# UNITED STATES PATENT AND TRADEMARK OFFICE

APPLICATION NO.	FILING DATE	FIRST NAMED INVENTOR	ATTORNEY DOCKET NO.	CONFIRMATION NO.
10/500,573	07/01/2004	Hiroshi Aruga	032404-080	4787

## Office Action Summary

## **DETAILED ACTION**

# FIG. 3

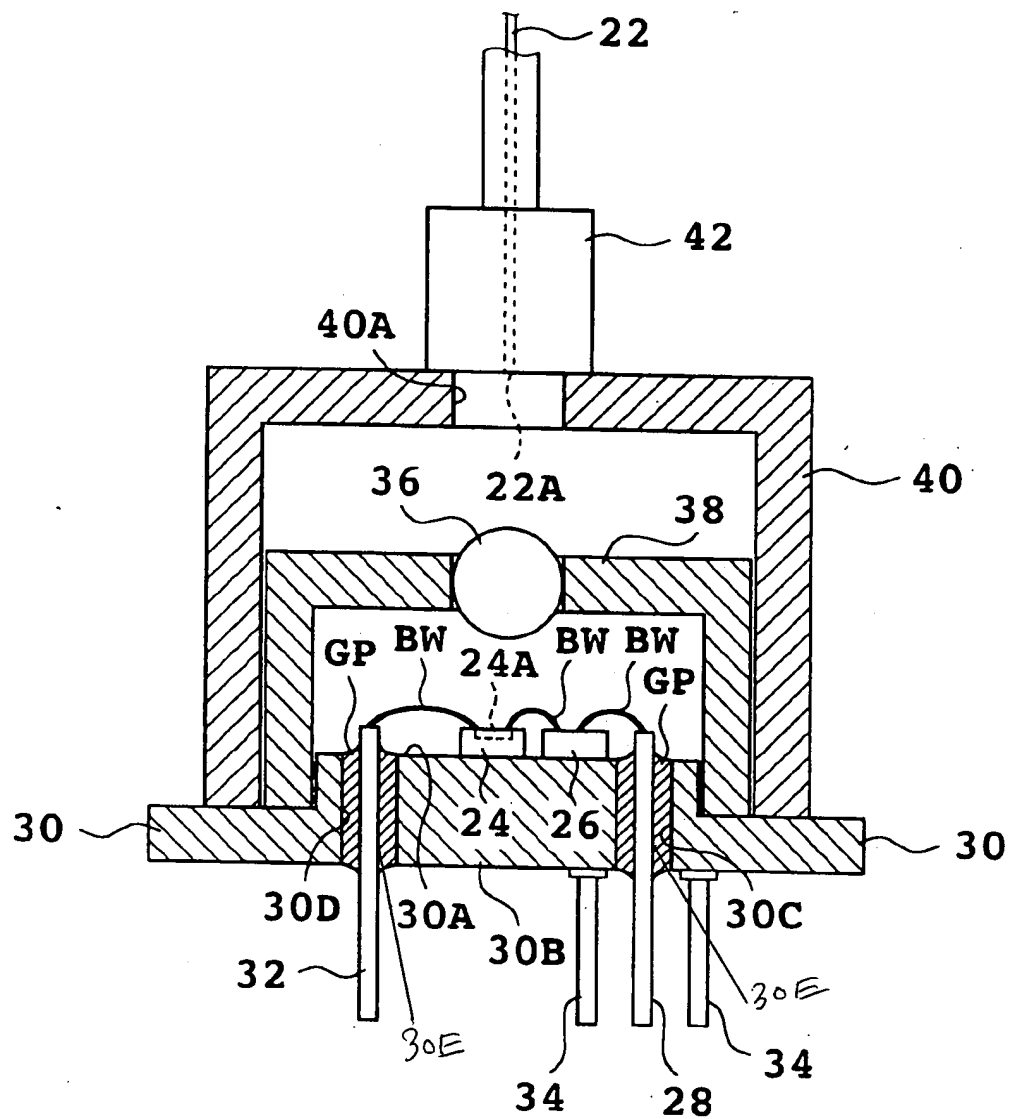
signals to and from the optical semiconductor element 24, the optical semiconductor package comprising: a dielectric (GP) sealed into and fixed to a wall surface of the package, and having a pair of pin insertion holes 30E; and a pair of signal pins (28,32) that penetrate through and fit into the pair of pin insertion holes 30E, and constituting differential lines, wherein differential signals are transmitted and received to and from the integrated circuit through the pair of signal pins (28,32). (Note attachment #1, fig. 3 of Oikawa).

With regard to claims 1,2, Oikawa discloses an optical semiconductor package for packaging therein an optical semiconductor element comprising a stem 30 with a hole 30C; a glass dielectric material (GP) sealed into the hole 30C of the stem 30, and with a pair of pin insertion holes 30E; and a pair of signal pins (28,32) that penetrate through and fit into the pair of pin insertion holes 30E of the glass dielectric material (GP), and that constitute differential lines electrically connected to the optical semiconductor element 24. (Note attachment #1, fig. 3 of Oikawa).

With regard to claim 6, Oikawa discloses a ground member 34 in parallel to the pair of the signal pins (28,32) is provided on the stem 30. (Note attachment #1, fig. 3 of Oikawa).

With regard to claim 11, Oikawa discloses a cap 40 that includes a light passing hole 40A and that airtight closes an internal space including the optical semiconductor element 24 by fixing an end portion to the stem 30. (Note attachment #1, fig. 3 of Oikawa).
